PLANNING CONSULTATION RESPONSE

Application No	2025/0127
Proposal	(AMENDED PLANS, RED LINE BOUNDARY AND DESCRIPTION) Residential development for 32 dwellings with associated landscaping and access.
Address	Land off South View, Darfield, Barnsley, S73 9NA.
Date of Consultation Reply	13/02/26
Consultee	Nik King, Senior Urban Design Officer

These are the 3rd set of design comments on planning application 2025/0127. These are made in the light of the amended plans received 09/12/25.

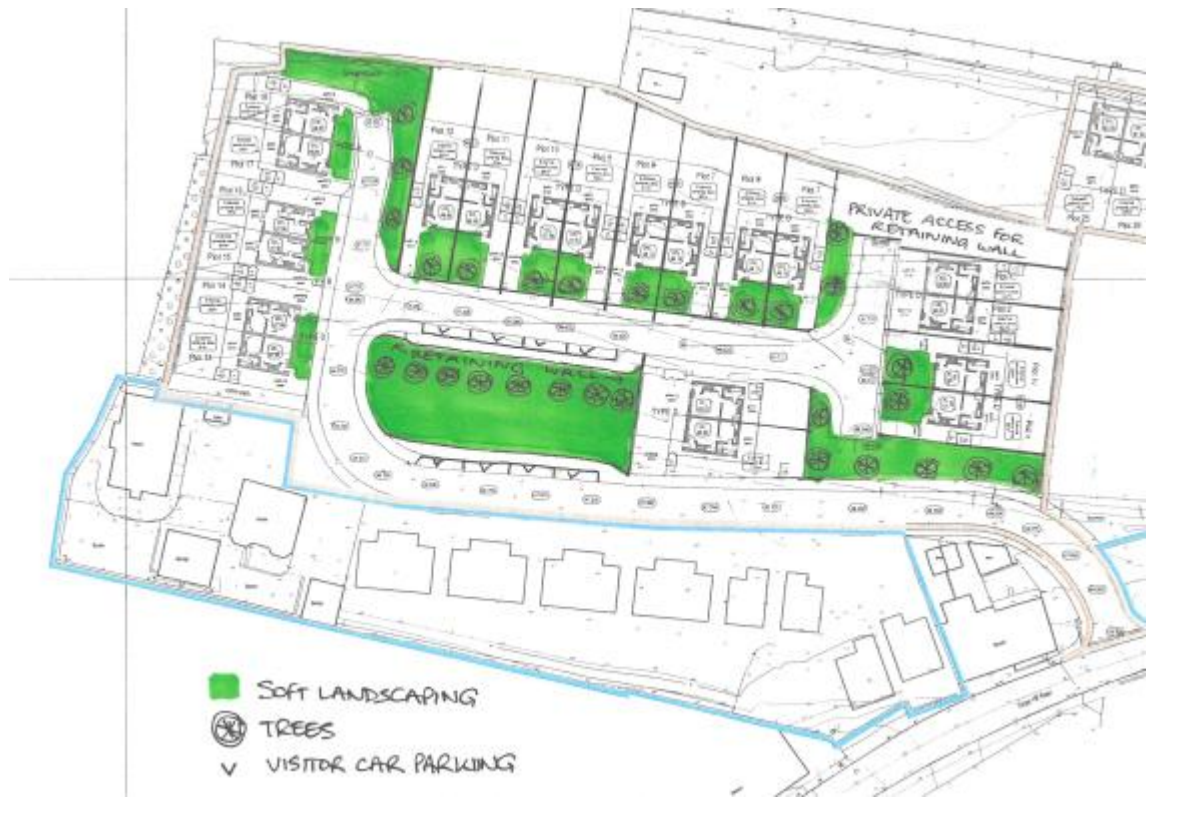
Below I have produced a suggested revised layout, with 20 dwellings in the main rectangular-shaped area. (I have amended site layout revision J). I appreciate that this main rectangular area is a difficult site to develop for housing.

In the suggested layout I have located the main POS more centrally, so it creates a focal point for the development and is flat in level across its extent. The SPD 'Open Space Provision on New Housing Developments' states (in para 14.2) '*open space should: be an integral part of the development and should usually form a central feature; not be located in peripheral areas of the site*'

This suggested location for the main POS also enables some space to be provided for visitor parking and also reduces some of the poor residential amenity problems identified above, (for example the north-south issues of overlooking/ front windows looking onto rear garden boundaries), that occurred in the proposed layouts.
